APPLICATION NO: 23/00536/OUT

**DESCRIPTION:** Outline planning application for up to 90 residential dwellings, including up to 40% affordable housing, creation of new vehicular access off Banbury Road and provision of public open space with associated landscape planting with associated infrastructure, drainage measures, earthworks and all other associated works. All matters reserved except accessibility to the site, for vehicles in terms of the positioning and treatment of access to the site

LOCATION: Land South of Hit or Miss Farm, Banbury Road, Chipping Norton, Oxfordshire

# ANNEX 1 COTSWOLDS NATIONAL LANDSCAPE CONSULTATION RESPONSE IN RELATION TO PLANNING APPLICATION 23/00536/OUT

Photoviewpoint EDP1 included within the LVA, December 2022

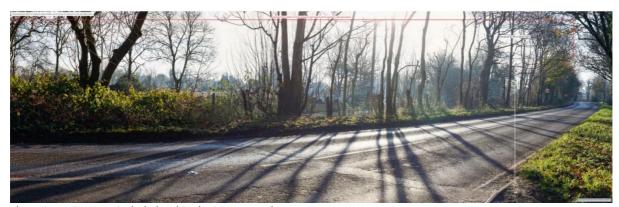
However, we note that the baseline conditions of the site have changed since the LVA was produced. Notably, the photography of the site from PVP1 was taken in December 2022, before a number of the roadside trees were removed earlier this year.

The current Google Streetview, dated March 2023 (below), shows the state of the road frontage following the removal of trees (understood to be works undertaken by the County Council due to Ash dieback) and illustrates that the site is now more visible from the National Landscape boundary on the northern side of Banbury Road than is shown in the LVA. This is acknowledged at paragraphs 6.7 and 7.45 of the LVA.

Having visited the site in July 2023, it is clear that roadside vegetation has since re-established itself to some degree, however the screening effect of this lower-lying vegetation will be lessened during winter months. It is also acknowledged that the footway on the northern side of Banbury Road (which DEFRA's MAGIC Map shows to be located within the National Landscape) is unlikely to be heavily used by walkers and that the receptors most affected by change would be drivers of vehicles and their passengers, who would experience a more transient view of the development than walkers.

Notwithstanding the above given that the proposal is for a major residential development directly opposite the boundary of a nationally-designated landscape, we request that a photomontage of the proposed development is provided from PVP1. This should depict the development and its associated landscape in wintertime conditions at Years 1 and 15, ideally using baseline imagery where the roadside Ash trees have been removed. This will allow the Board to come to a conclusion as to whether or not we agree with the applicant's assessment of a moderate/minor adverse level of effect at Year 1, reducing to minor by Year 15.

Without prejudice, should the Council be minded to approve the application, we recommend that any reserved matters application should pay particularly careful attention to the replacement and enhancement of tree planting and hedgerow along the roadside boundary to create a long-term screen to the development and maintain the distinctive soft, tree lined approach to Chipping Norton.
